SHOWGROUND PRECINCT EAST

BUILDING A, B & C

SSD 62802207 MOD Proposed Facade Changes- Comparison Schedule

PROPOSED FACADE DEVELOPMENT

BUILDING B- ELEVATION COMPARISON

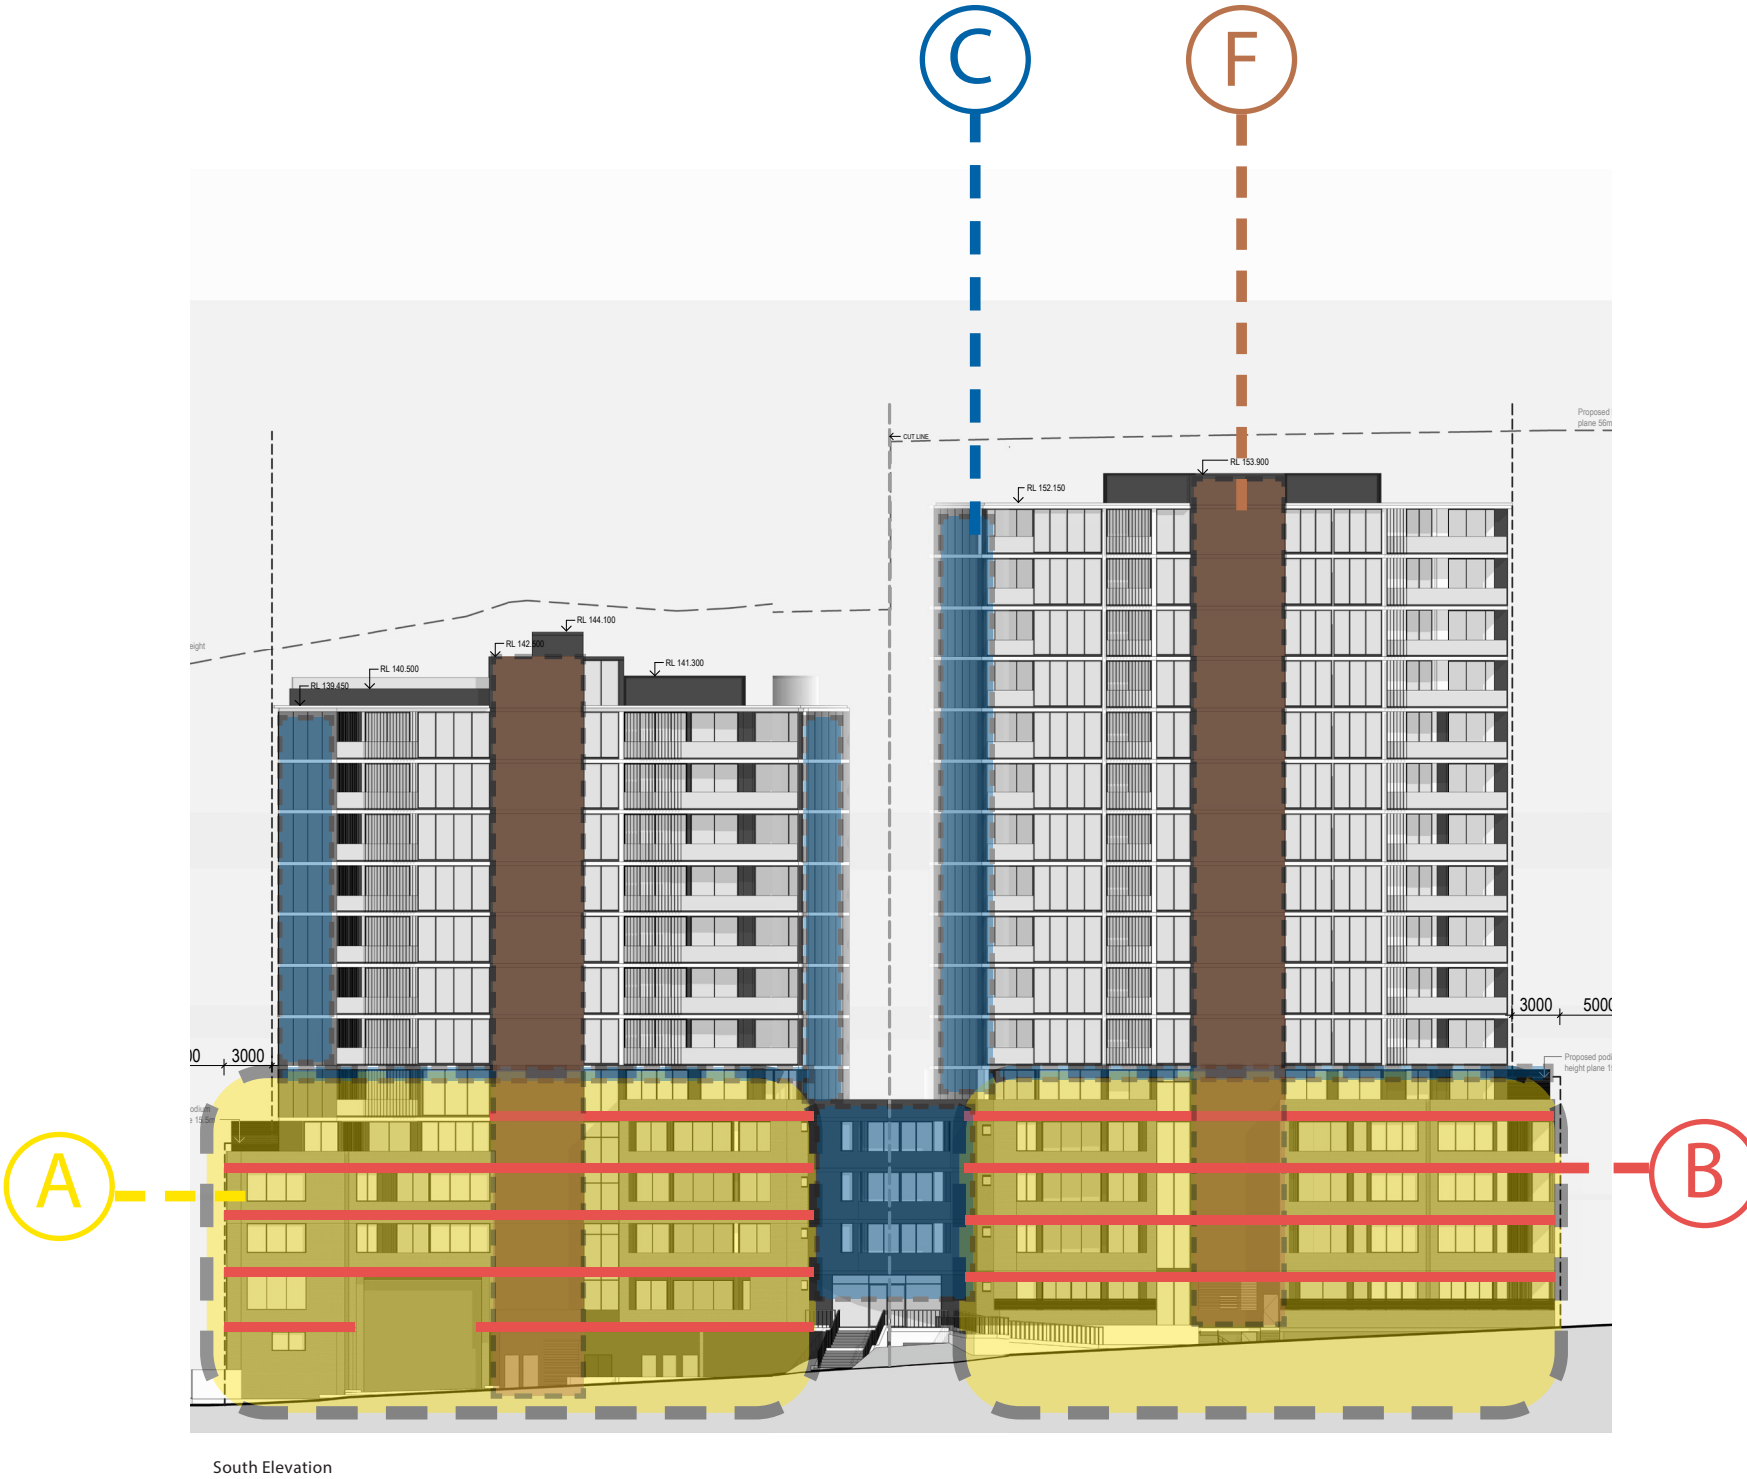
- A. Replaced applied tiles at podium levels with brickwork
- B. Exposed painted slab to podium level
- C. Replaced metal cladding/ brick panels to FC cladding to all tower facade
- D. Rationalised balustrades type to either full glass balustrade or full solid balustrade
- E. Adjustment to screens
- F. Lift and stair core walls changed to rendered and painted finish
- G. Upgrade windows at level 1-3 in Building C to full height glazing
- H. Remove roof frame
- N. Remove splay edges in Building A facade

SSD 62802207 Approved Facade Changes
North Elevation

Proposed Facade Changes:
North Elevation

BUILDING B- ELEVATION COMPARISON

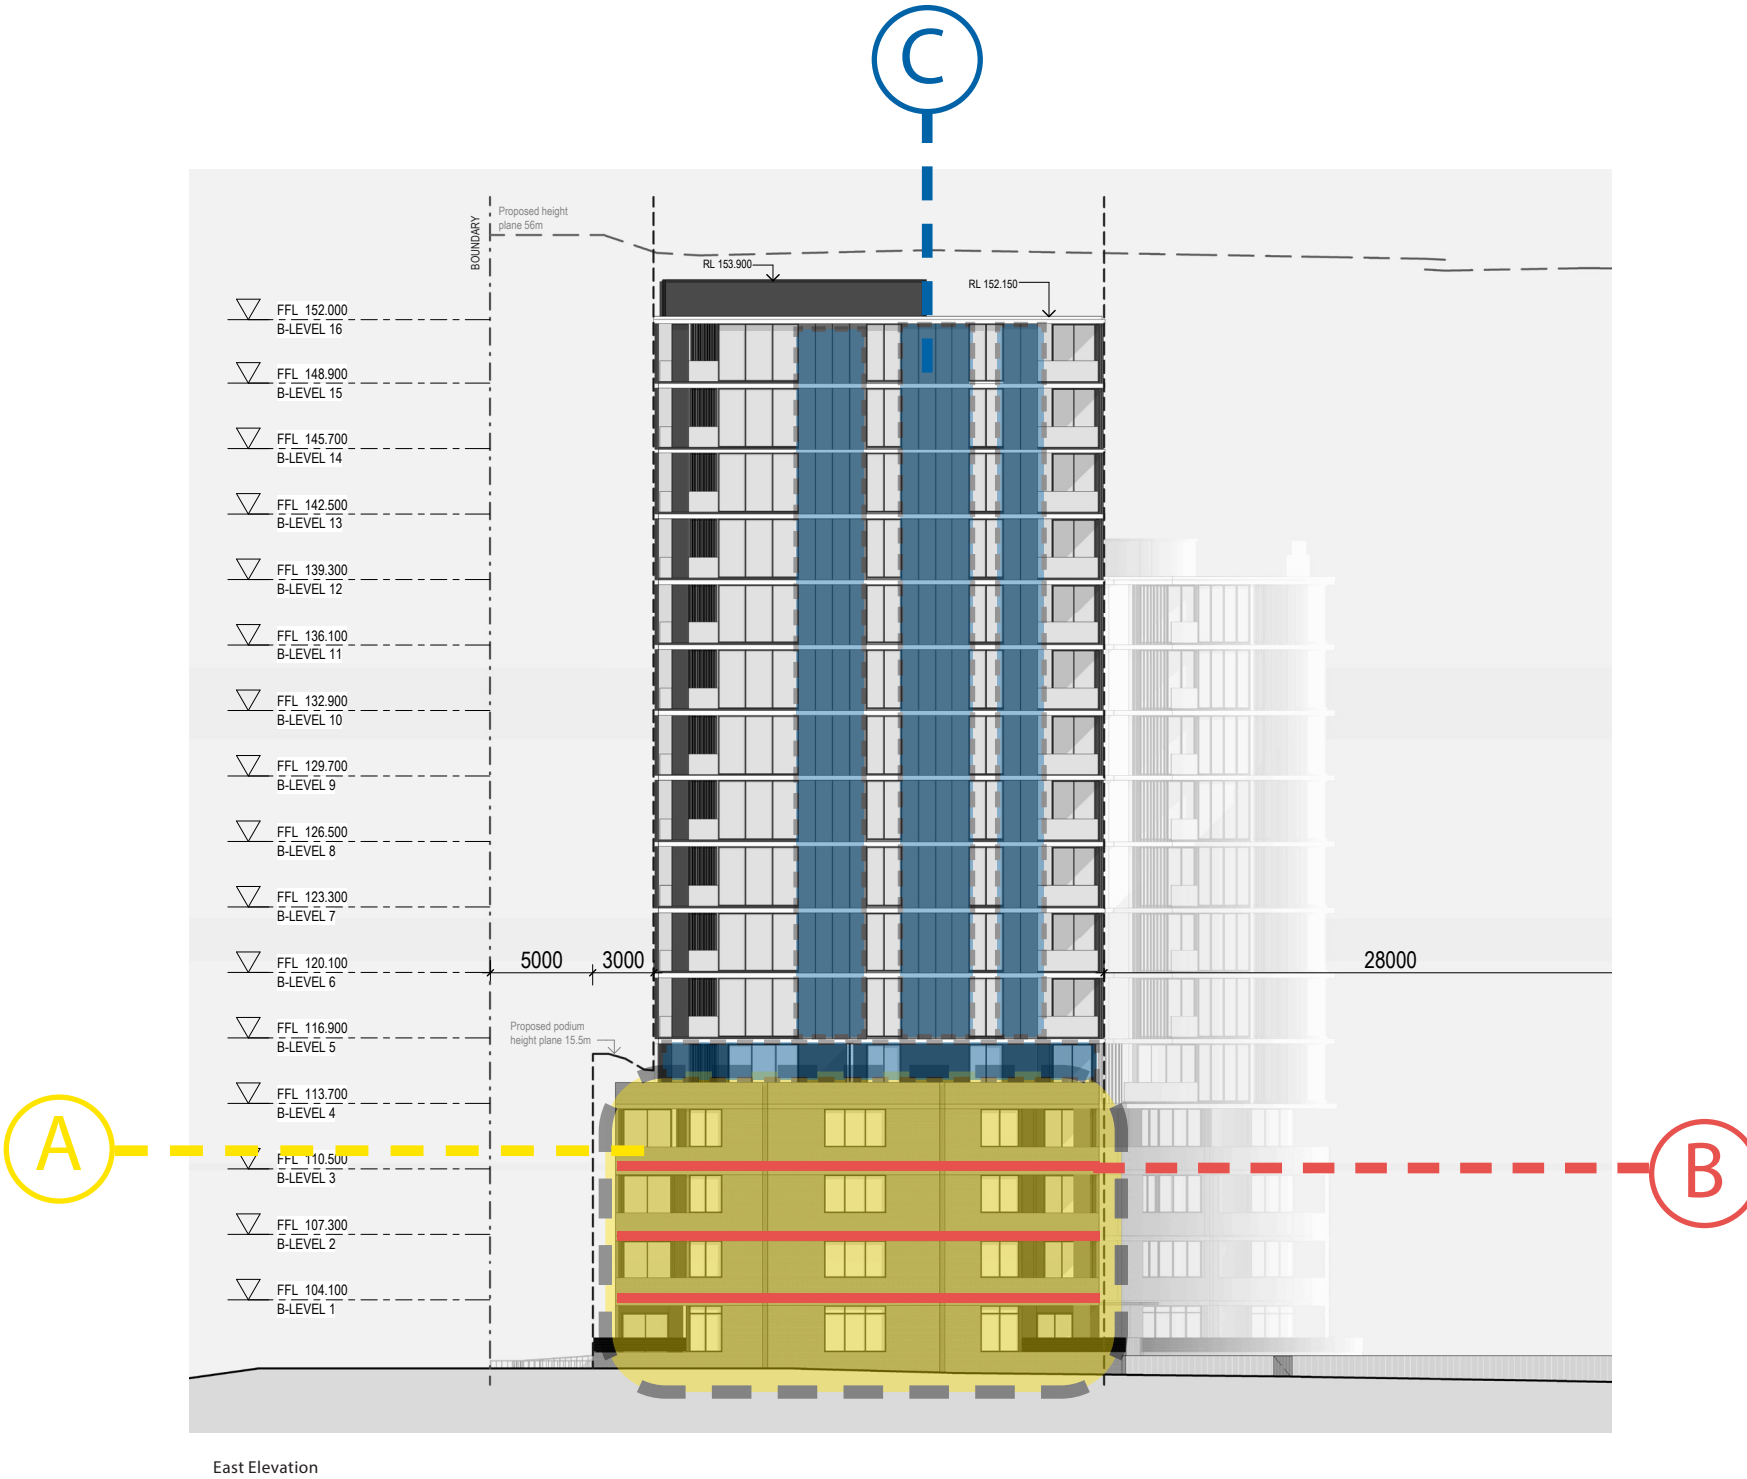
- A. Replaced applied tiles at podium levels with brickwork
- B. Exposed painted slab to podium level
- C. Replaced metal cladding/ brick panels to FC cladding to all tower facade
- D. Rationalised balustrades type to either full glass balustrade or full solid balustrade
- E. Adjustment to screens
- F. Lift and stair core walls changed to rendered and painted finish
- G. Upgrade windows at level 1-3 in Building C to full height glazing
- H. Remove roof frame
- N. Remove splay edges in Building A facade

SSD 62802207 Approved Facade Changes
South Elevation

Proposed Facade Changes:
South Elevation

BUILDING B- ELEVATION COMPARISON

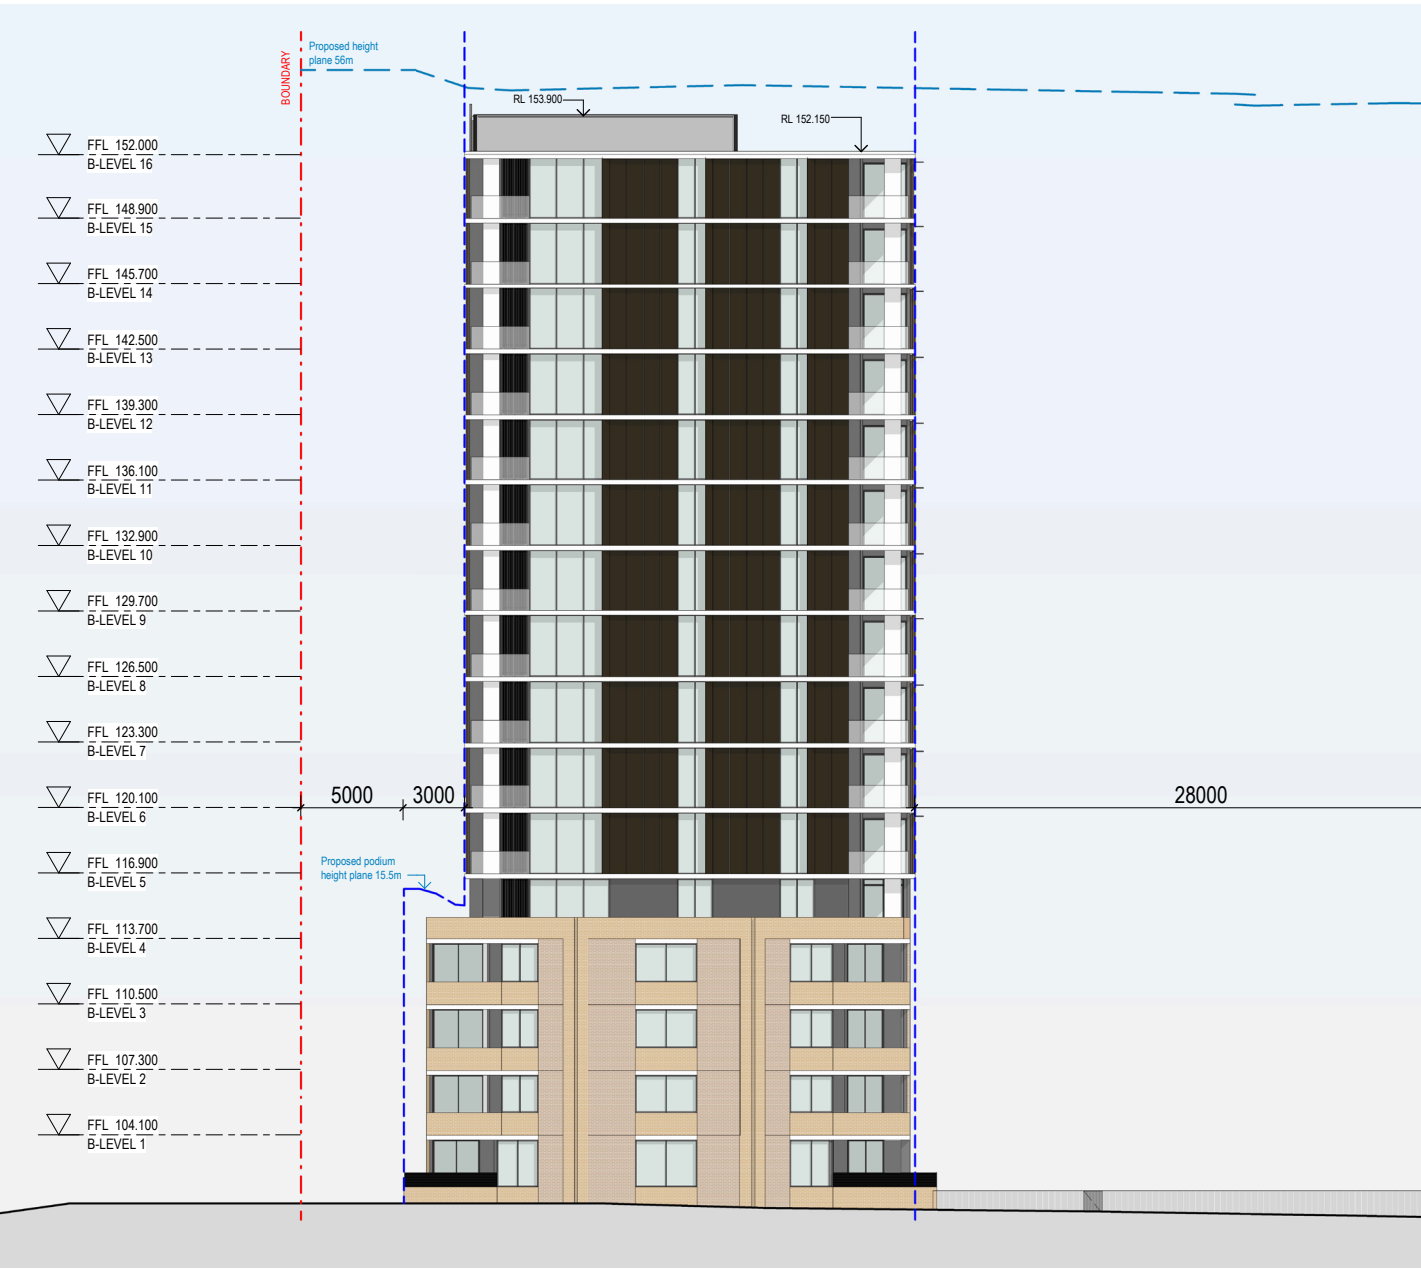
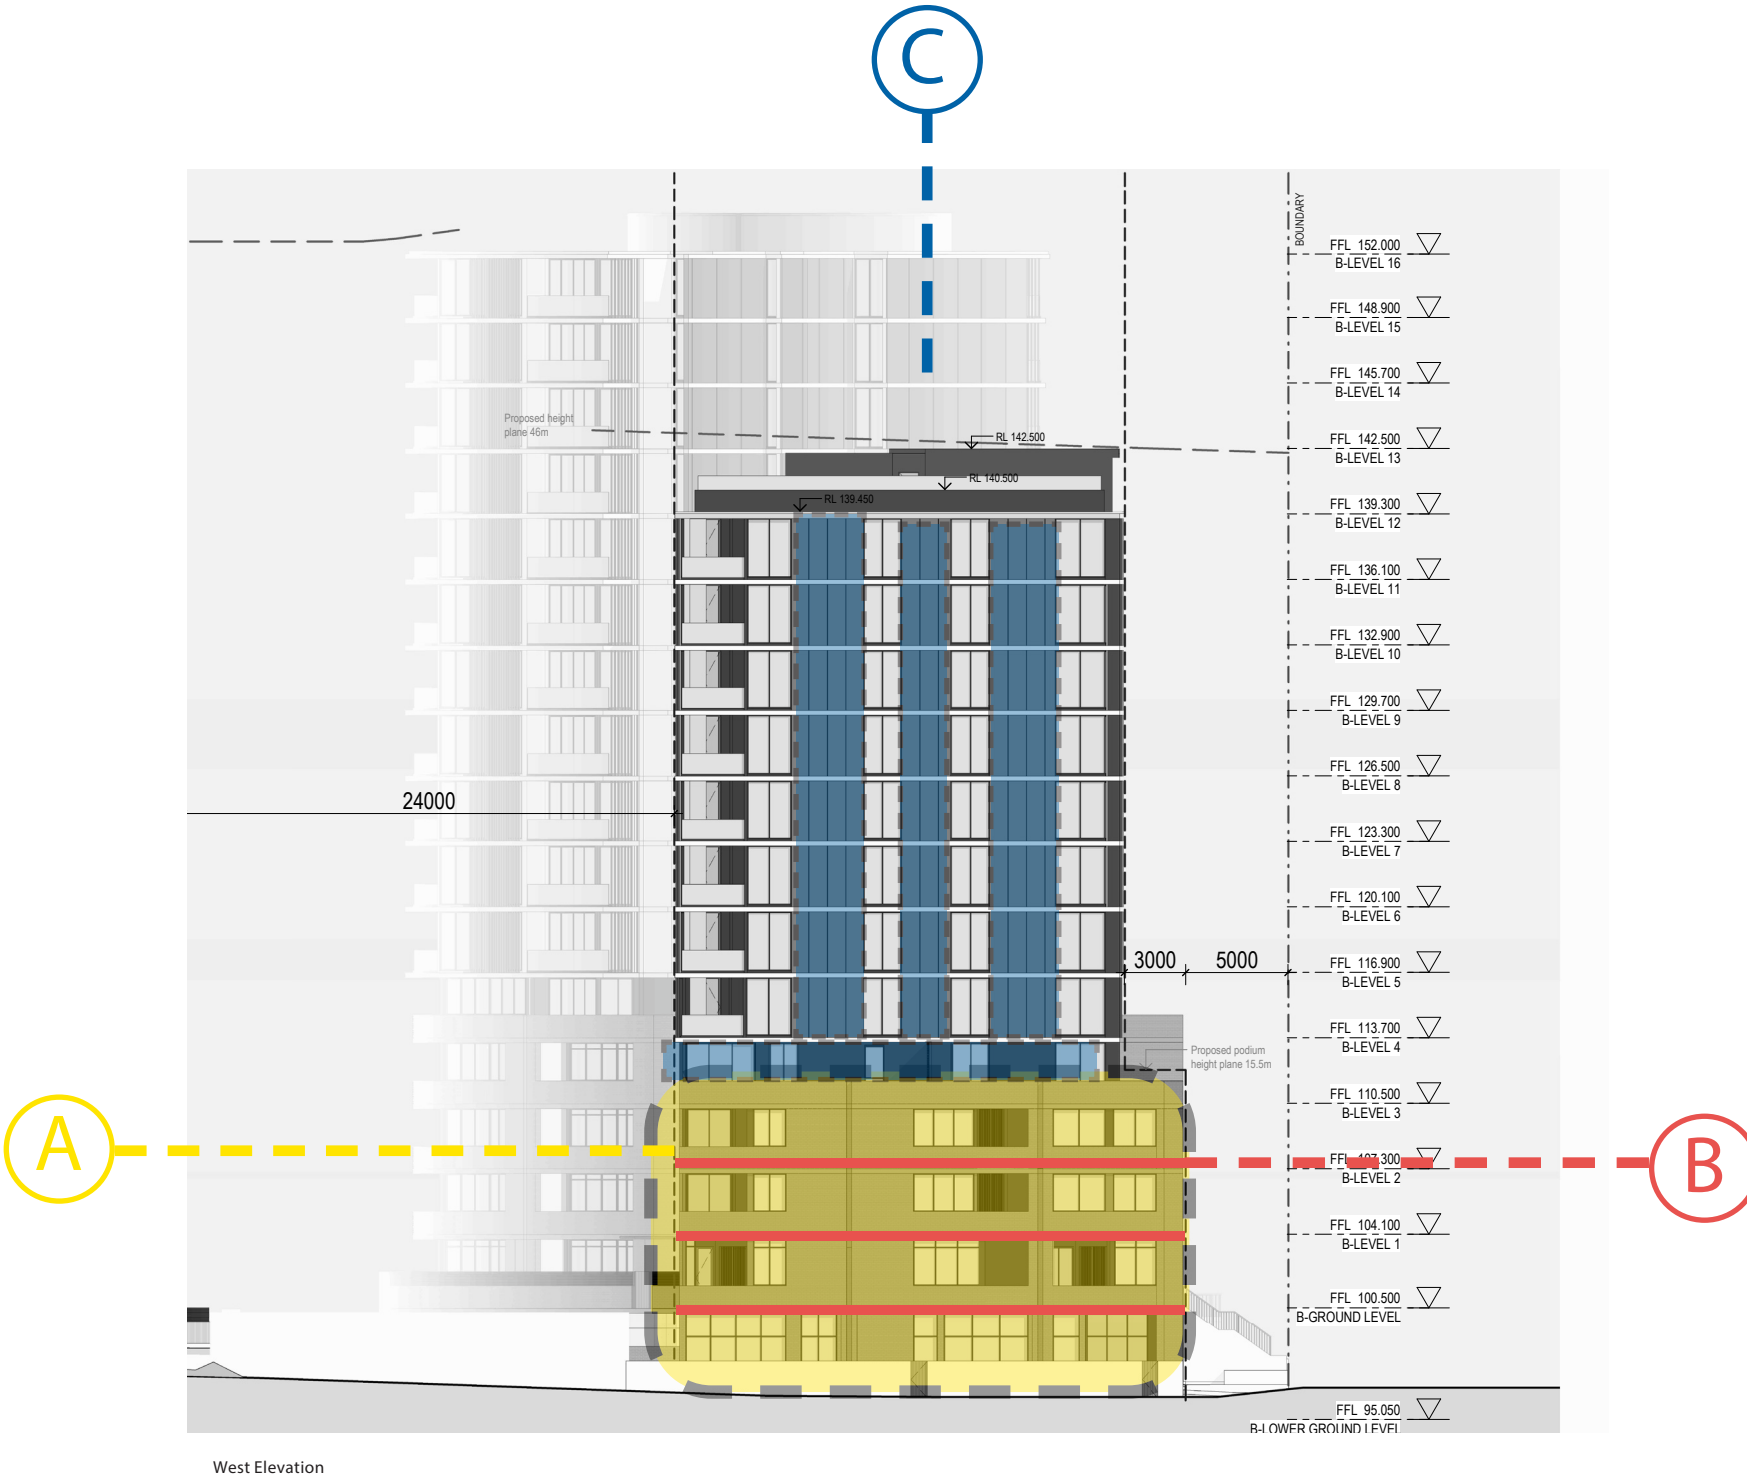
- A. Replaced applied tiles at podium levels with brickwork
- B. Exposed painted slab to podium level
- C. Replaced metal cladding/ brick panels to FC cladding to all tower facade
- D. Rationalised balustrades type to either full glass balustrade or full solid balustrade
- E. Adjustment to screens
- F. Lift and stair core walls changed to rendered and painted finish
- G. Upgrade windows at level 1-3 in Building C to full height glazing
- H. Remove roof frame
- N. Remove splay edges in Building A facade

SSD 62802207 Approved Facade Changes
East Elevation

Proposed Facade Changes:
East Elevation
